ADDENDUM #1

Job #: 190970 **Project Title** Alexandria Lower Dam Improvements
Client: City of Alexandria

Issue Date: February 16, 2023
Bid Date: February 21, 2023

FLEXAMAT STANDARD - CHANNEL LAYOUT PERPENDICULAR TO FLOW

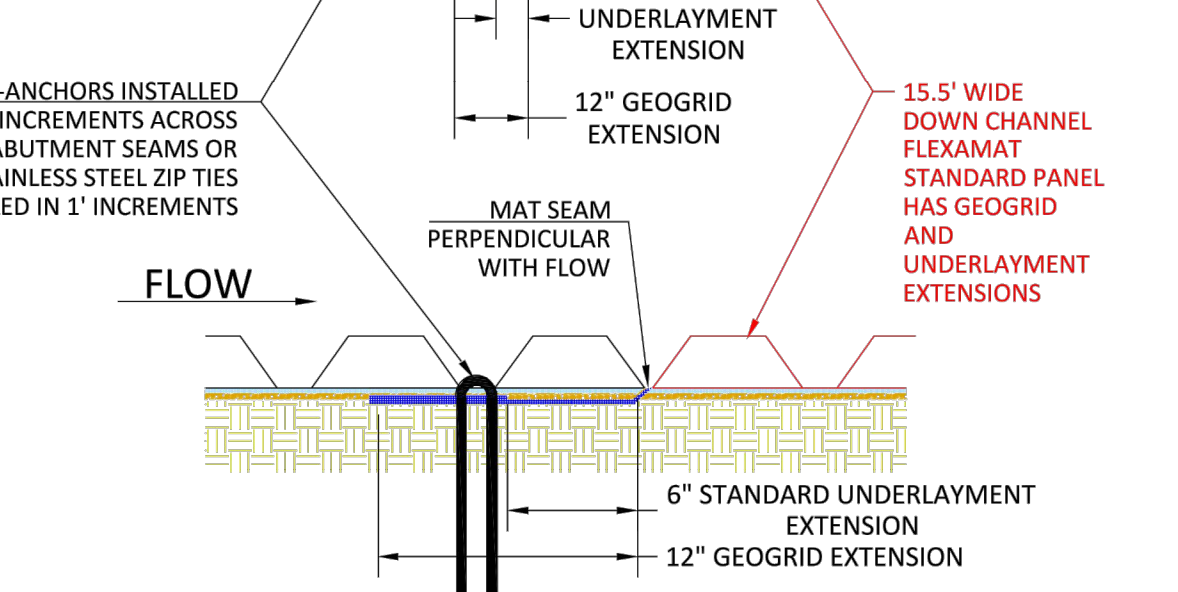
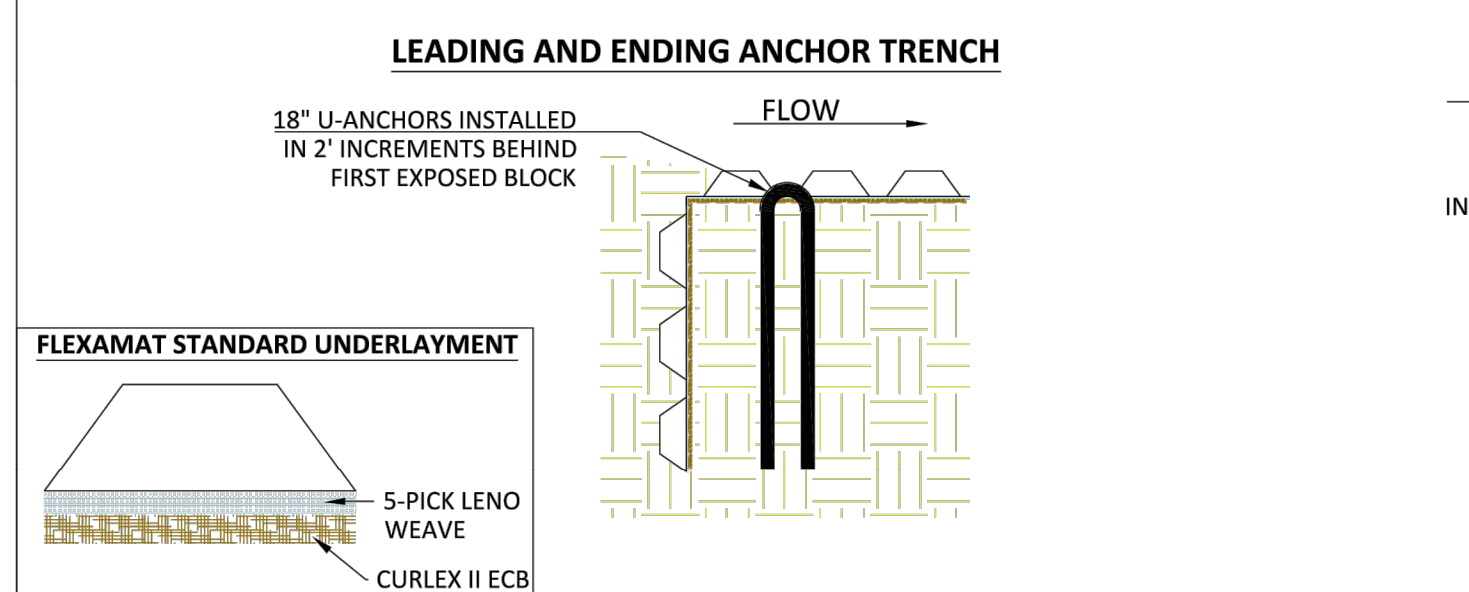
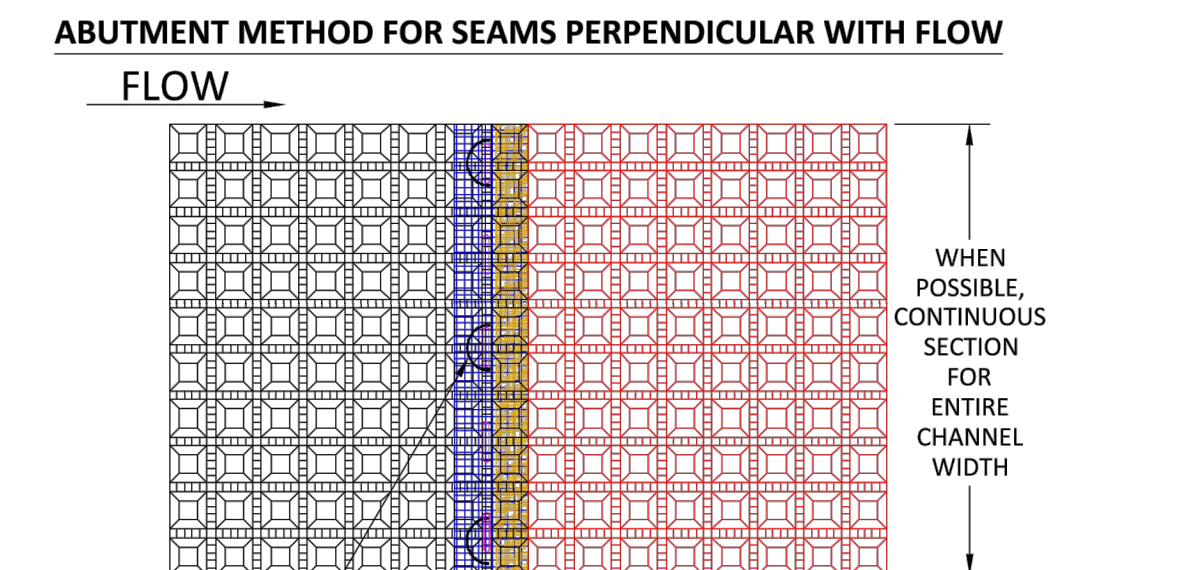
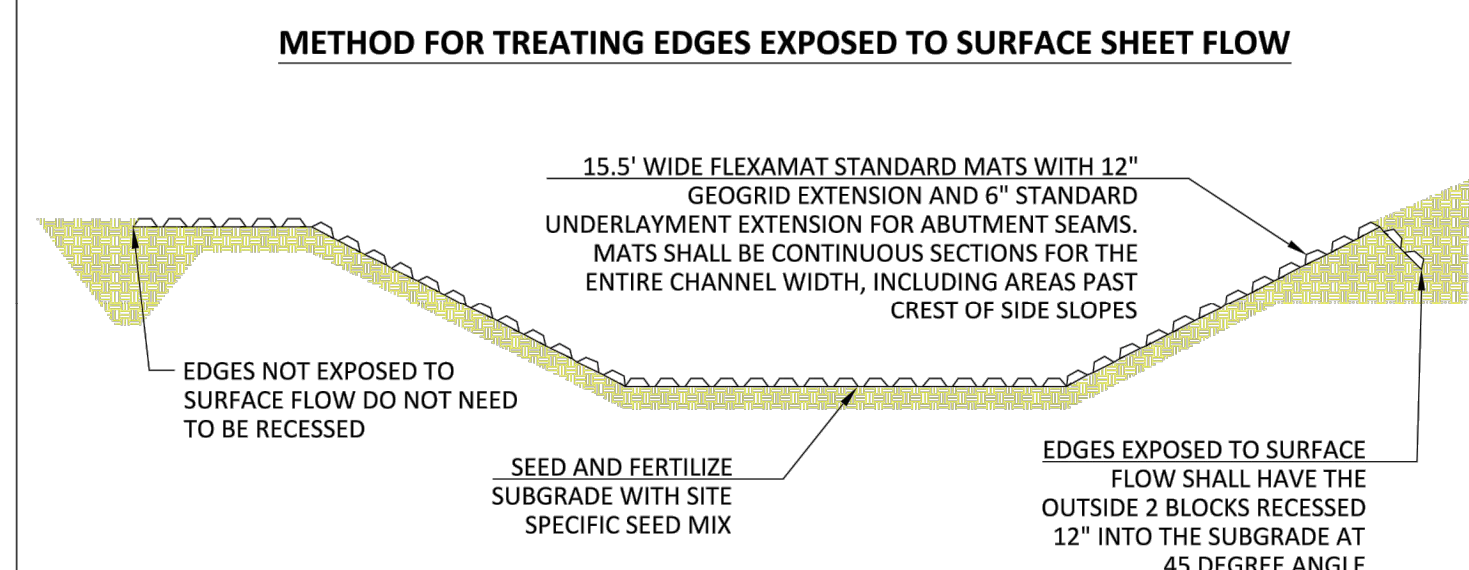
Finish grade of side slopes shall be feathered over the first two rows of block along the outside edges of channel.

1' Geogrid and Curlex II Underlayment Extension on 15.5' wide rolls.

Per discussion with Robert Seitzinger with CT Consultants - installing 15.5' wide rolls with geogrid and Curlex II Extensions and 16' wide roll no extensions adjacent to each other for a total width of 31.5'. This will allow for approximately 3' - 3" up each side slope of the spillway channel.

**ALEXANDRIA LOWER DAM
IMPROVEMENTS
CITY OF ALEXANDRIA
CAMPBELL COUNTY, KENTUCKY
PLAN SHEET 2
NORTH OF TOP OF DAM**

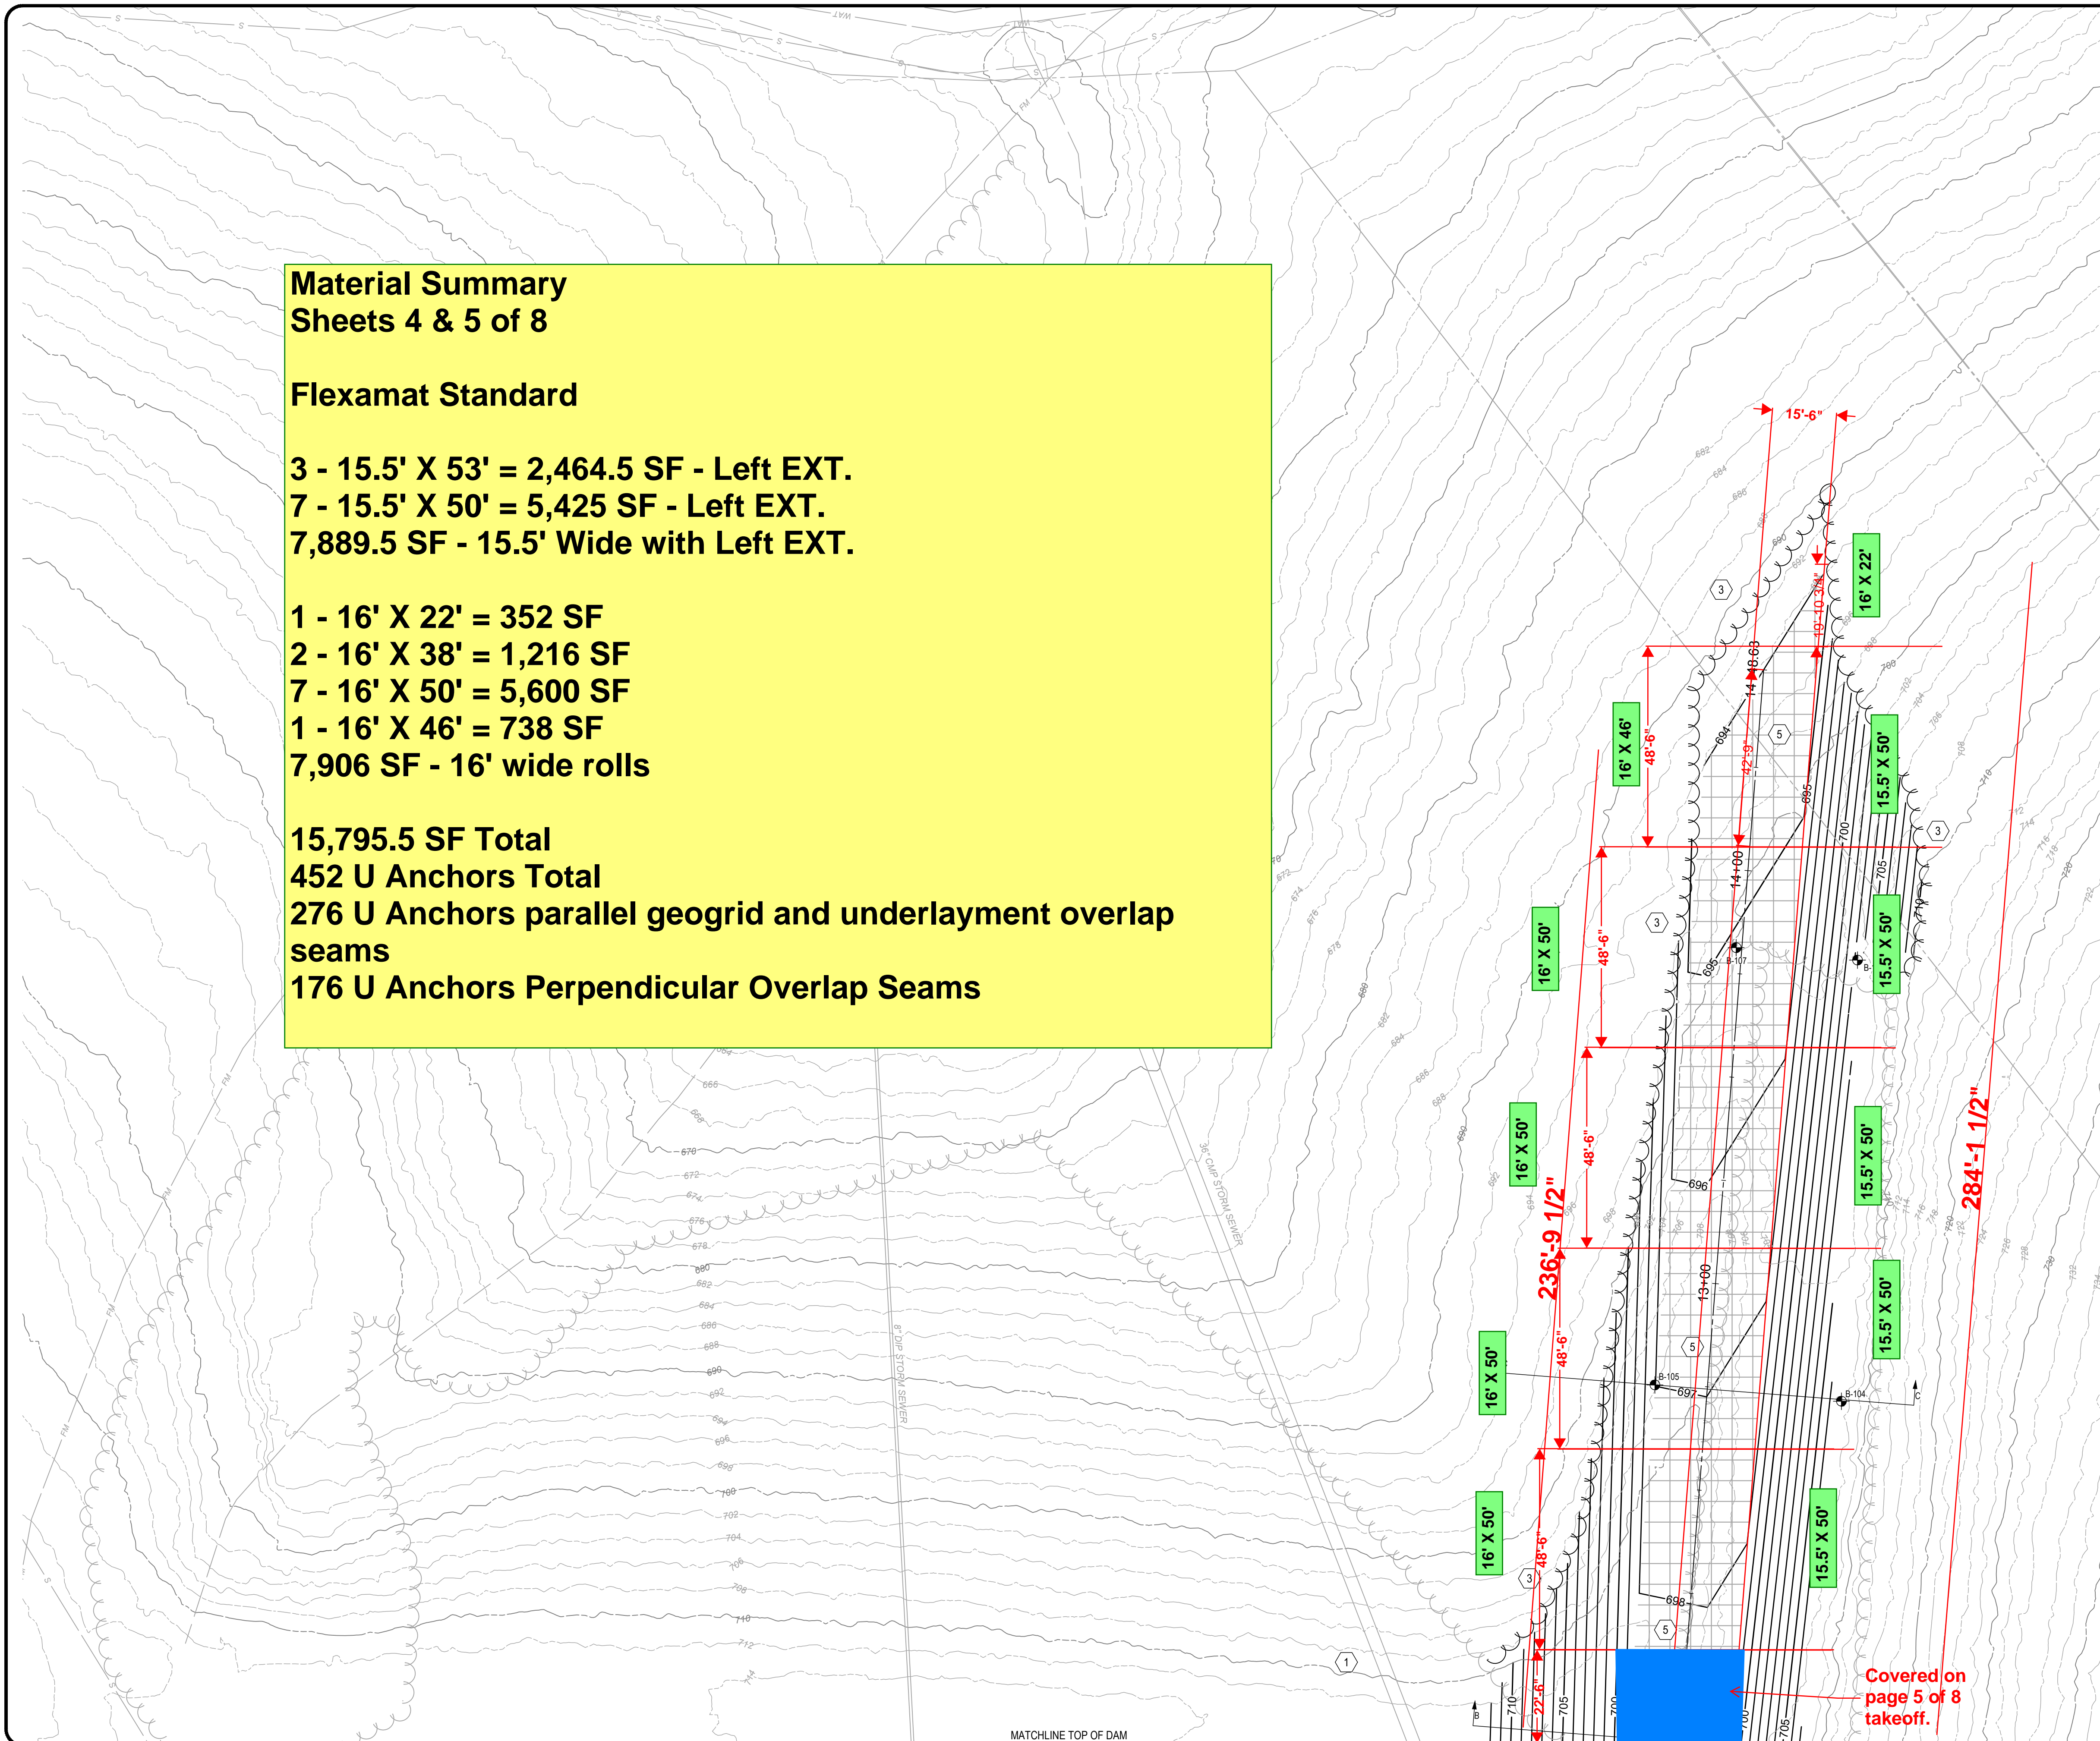
**Material Summary
Sheets 4 & 5 of 8**

**3 - 15.5' X 53' = 2,464.5 SF - Left EXT.
7 - 15.5' X 50' = 5,425 SF - Left EXT.
7,889.5 SF - 15.5' Wide with Left EXT.**

**1 - 16' X 22' = 352 SF
2 - 16' X 38' = 1,216 SF
7 - 16' X 50' = 5,600 SF
1 - 16' X 46' = 738 SF
7,906 SF - 16' wide rolls**

**15,795.5 SF Total
452 U Anchors Total
276 U Anchors parallel geogrid and underlayment overlap seams
176 U Anchors Perpendicular Overlap Seams**
